RE: 36 Champeaux Road (DEP File No. CE 300-1194)

Subject: DEP Comments Response Letter

PROPOSED SINGLE FAMILY HOME
 36 CHAMPEAUX ROAD
 STURBRIDGE, MA 01518
 PREPARED FOR
 KEVIN LAMY
 33 PAIGE ROAD
 BRIMFIELD, MA 01507

OVERALL SITE PLAN
C-2

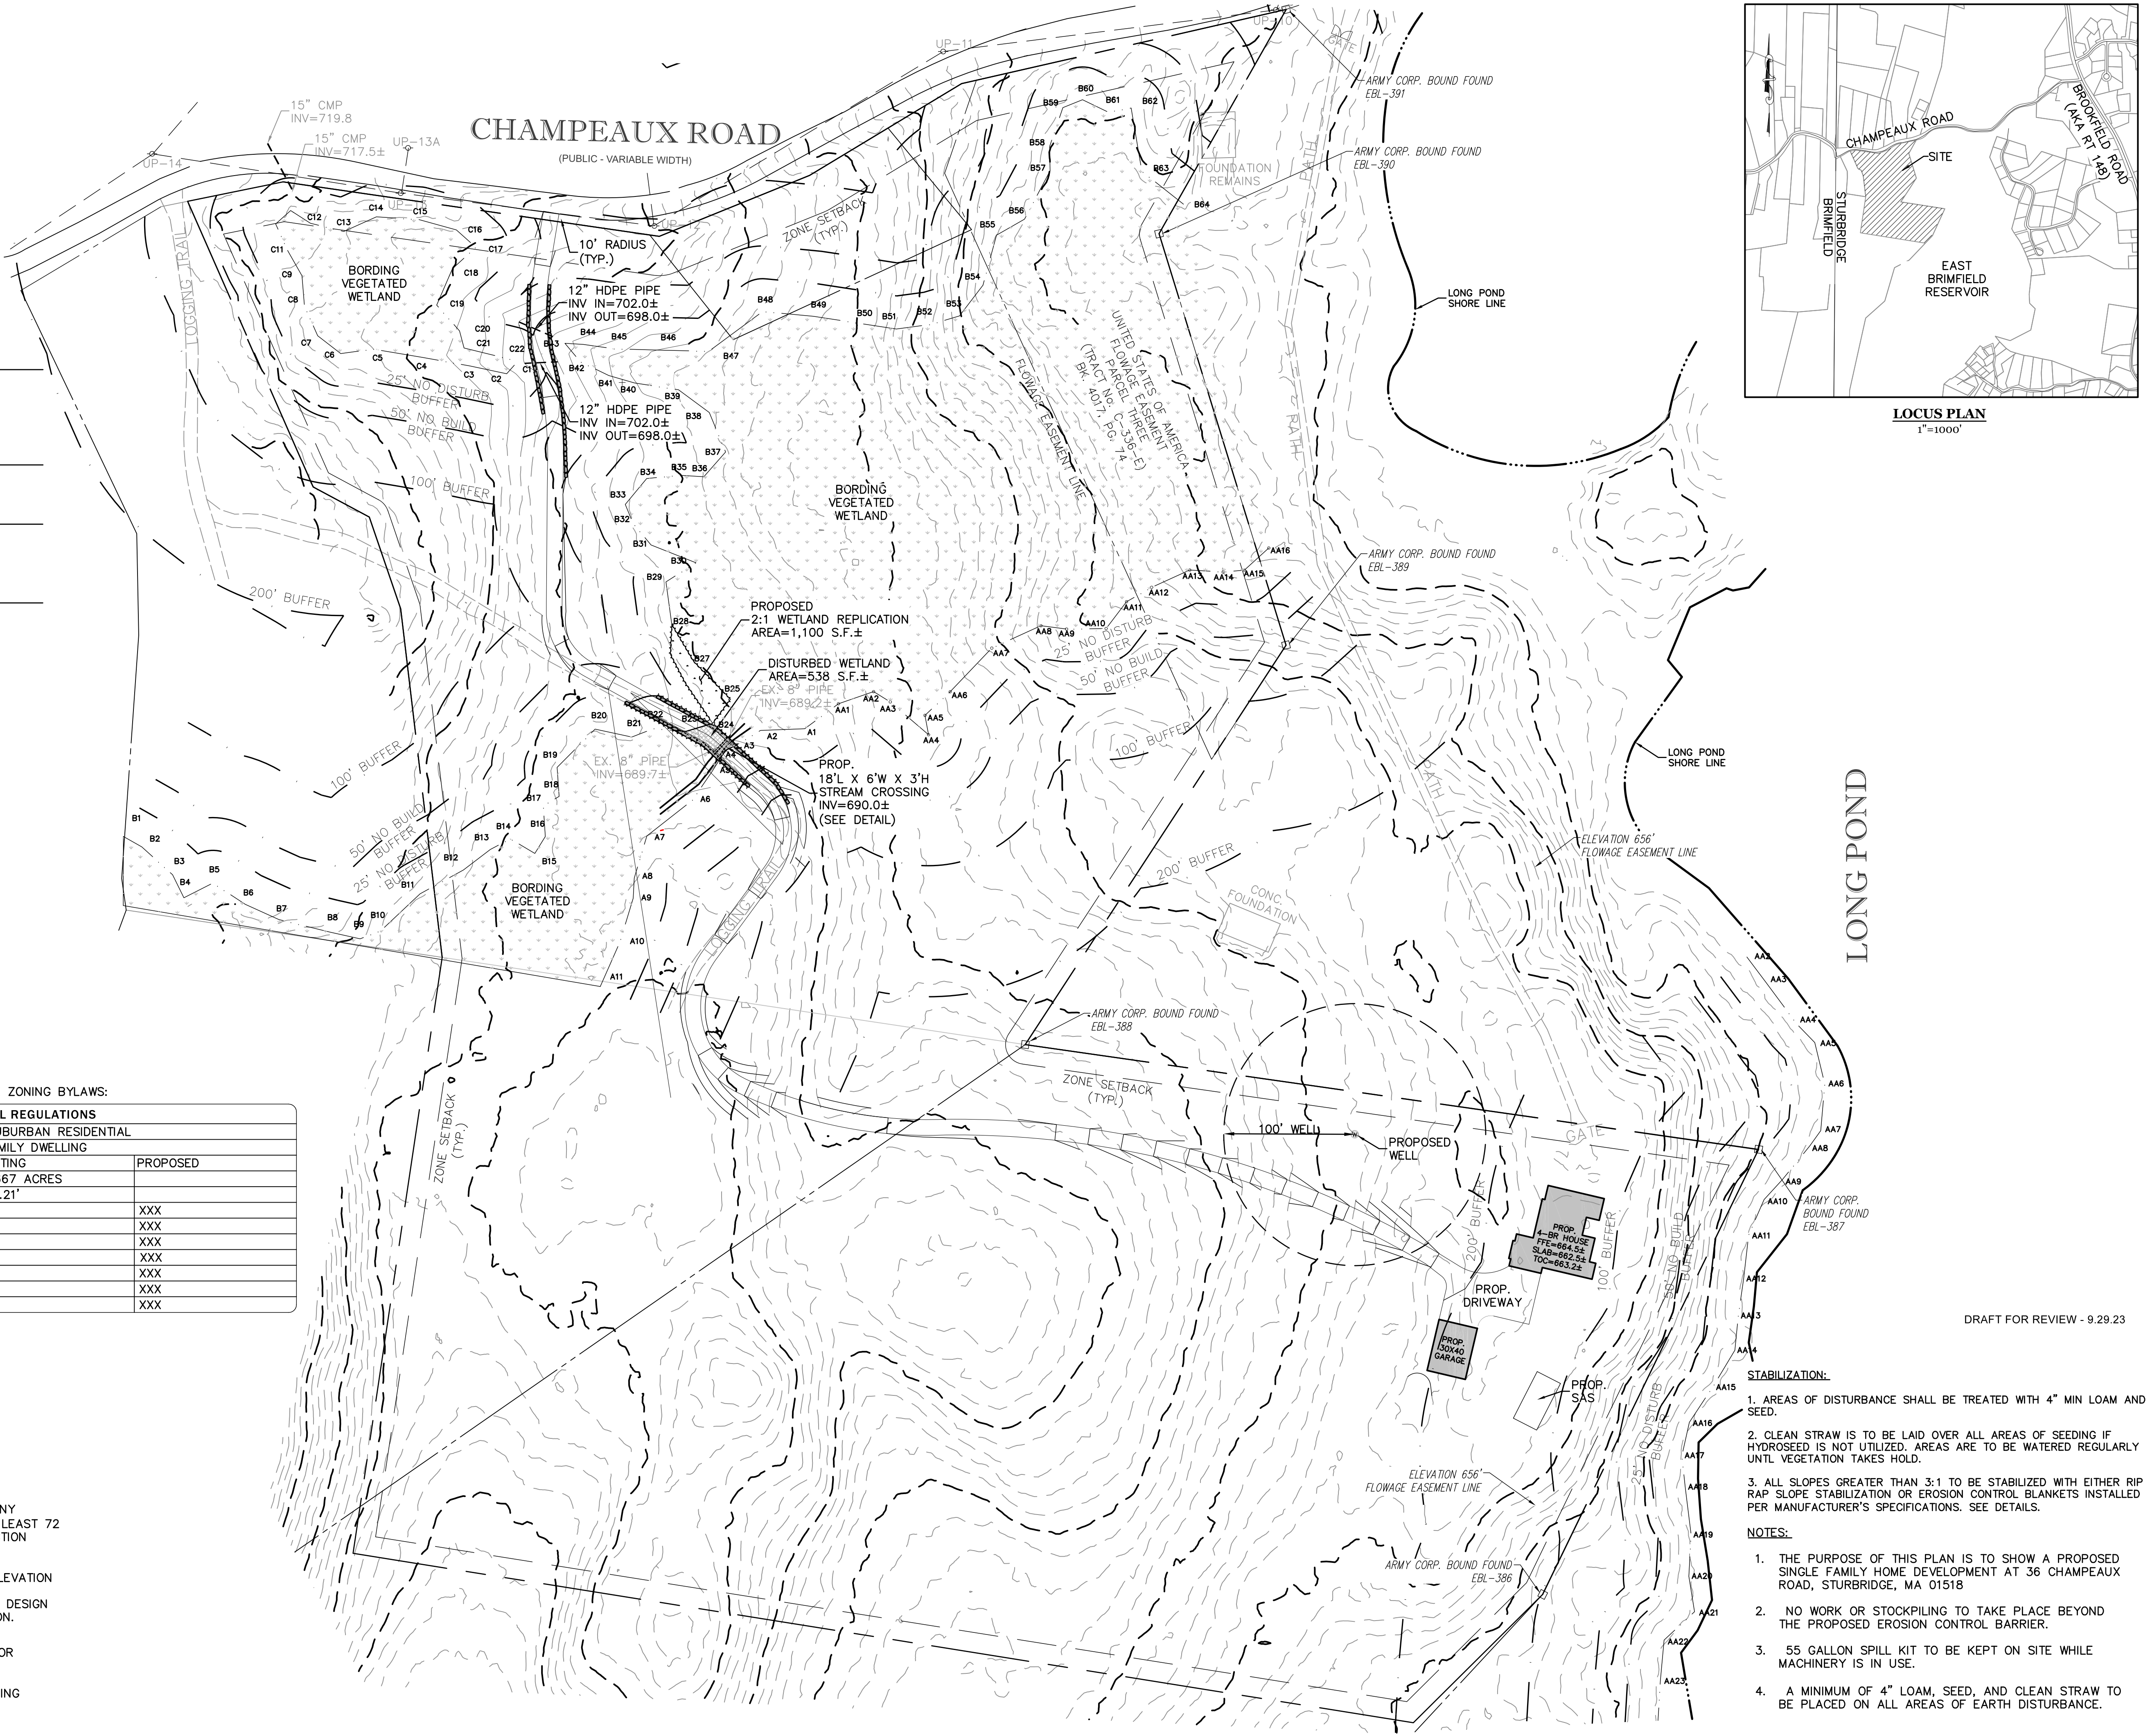
*Comment: A detail on the plan refers to the crossing as a stream crossing. What is bankfull width? How was bankfull width determined? How does this proposed crossing meet Stream Crossing Standards? Are there impacts to Bank?

Response: EcoTec field measured the bankfull width at the crossing and determined that the average width at the easterly end was approximately 3.5 feet and the width at the southerly end was approximately 4.3 feet wide. The proposed 6 foot wide culvert has been designed to fully span the channel by at least 1.2 times its width; and meets the openness ratio under the Mass Stream Crossing Standards. No impacts to the Bank are proposed or anticipated.
